Meeting Minutes: NEC 2026 Adoption Review Committee (Board of Electricity)

Date: Oct. 28, 2025

A. Committee review of the 2026 NEC – Cost Analysis Review & Wrap-up | Dean Hunter

110.16 Arc-Flash Hazard Marking.

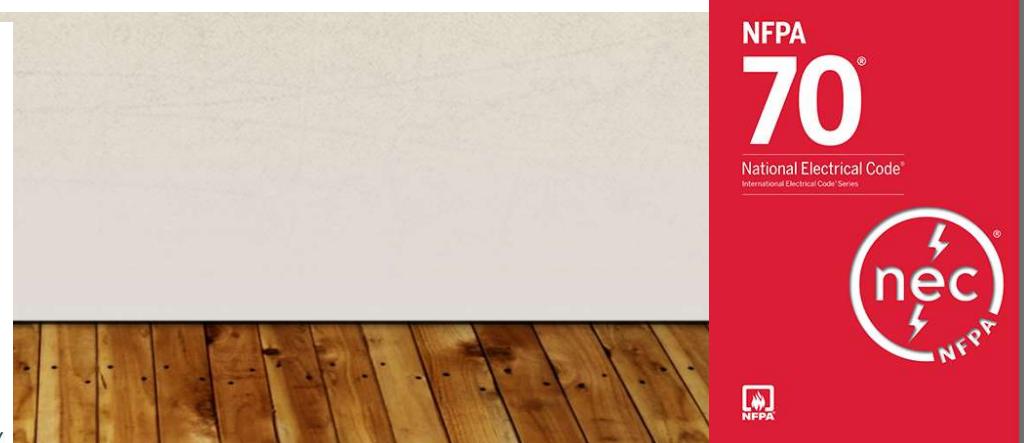
- **Presentation Summary – Trevor Turek (110.16, 2026 NEC)** – see **Attachment B**
 - Trevor Turek presented on NEC section 110.16, referencing his presentation titled 110.16, 2026 NEC, and provided historical context, noting arc flash labeling requirements began in the 2002–2005 NEC editions.

- The 2026 NEC specified new label requirements: nominal system voltage, arc flash boundary, available incident energy, and the date.
 - Compared the 2026 NEC language with the 2020 NEC, noting that while the requirements were similar, the 2026 version explicitly listed arc flash boundary and incident energy.

- Emphasized that these values were already necessary in 2020 for selecting proper PPE, making the change more of a clarification than a new requirement.

ANNEX C BOUNDARIES

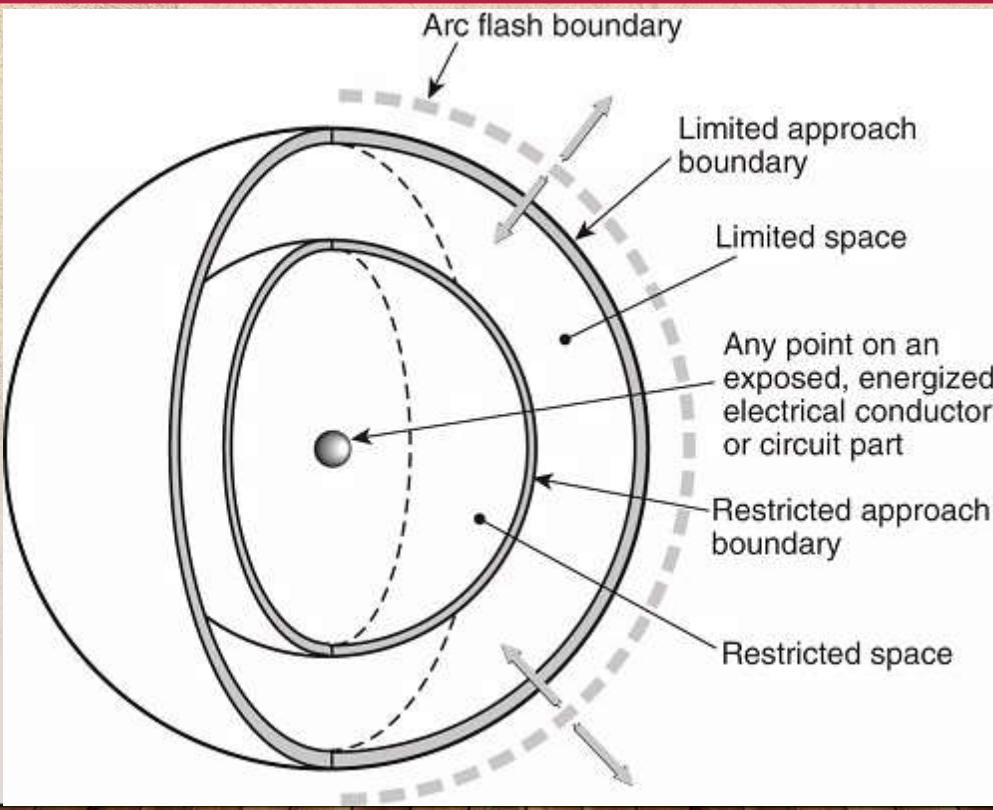
- Informational Note 2 in 110.16 directed users to NFPA 70E for compliance guidance, which is available online.
 - Explained the concept of arc flash boundaries using an image from Annex C of NFPA 70E, noting that the boundary is dynamic and depends on incident energy, fault current, and overcurrent device clearing time.

- Clarified that the arc flash boundary represents the distance at which incident energy equals 1.2 cal/cm²—the threshold between a sunburn and a second-degree burn.
